SEWAGE DISPOSAL SYSTEM
HOWARD COUNTY HEALTH DEPARTMENT
BUREAU OF ENVIRONMENTAL HEALTH
410-313-2640

P 515291-A

A REPAIR

DRYWELL REHABILITATION (SEE REVERSE)

NOT TO SCALE

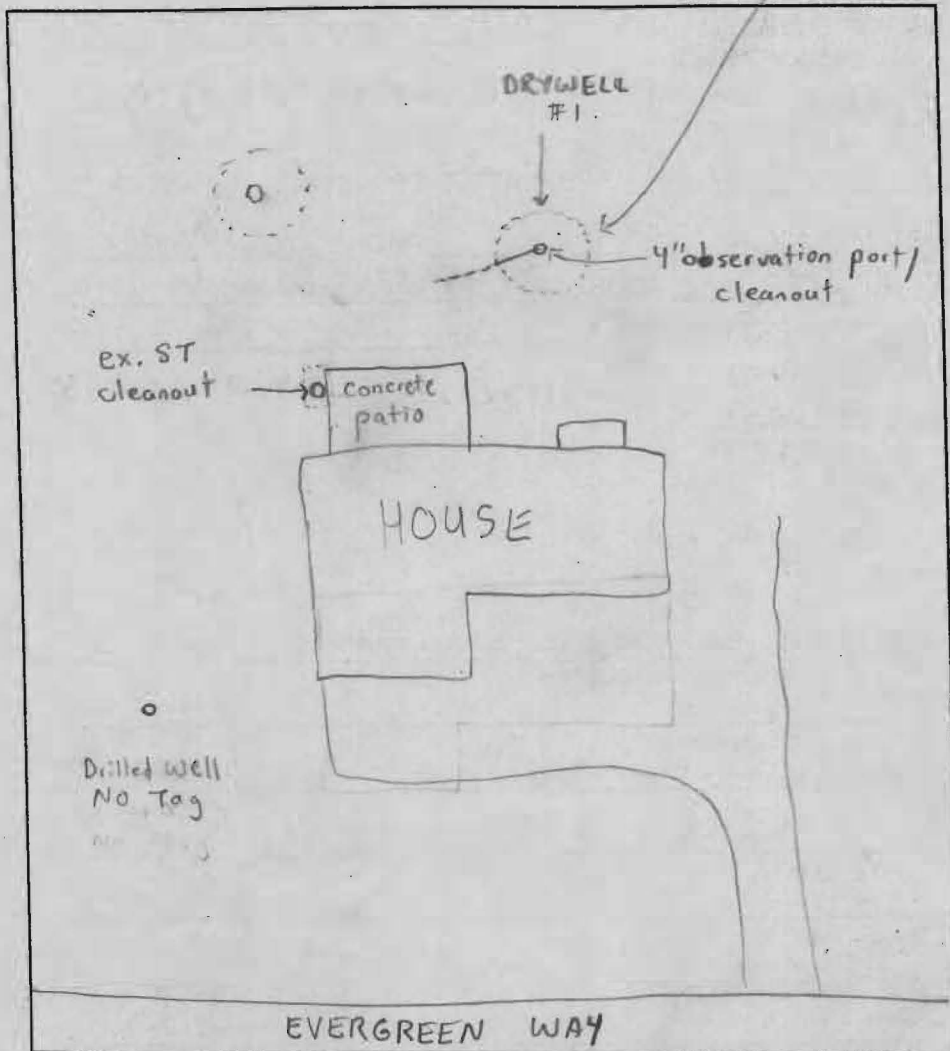
PRE-CONSTRUCTION INSPECTION: 6/20/01 - EX. DRYWELL EXCAVATED, LIDS SLIGHTLY COLLAPSED, SEWAGE LEVEL ABOUT 14" ABOVE DRYWELL BOTTOM, OWNER WOULD RATHER TRY TO REHABILITATE DRYWELL BY PUMPING, FILLING WITH #2 STONE AND PLACING 4" PERFORATED PIPE IN CENTER TO HELP SERVE AS A MONITORING PIPE/DISTRIBUTION PIPE - THIS ARRANGEMENT ACCEPTABLE (SRK)
 INSPECTION COMMENTS: 6/20/01 - (DRYWELL ONLY) 5' DEEP (MEASURED FROM LID TO BOTTOM OF DRYWELL)

DRYWELL HAS 6' OF COVER TO LID, INLET INTO DRYWELL 7' DEEP - PVC HOOKED TO EX. CAST IRON W/ FERRO COUPLING, TEE IN CENTER OF DRYWELL, OK TO COVER ALL WORK STONE ADDED INTO DRYWELL (MAKING A CIRCULAR LEACHING BED) (SRK)
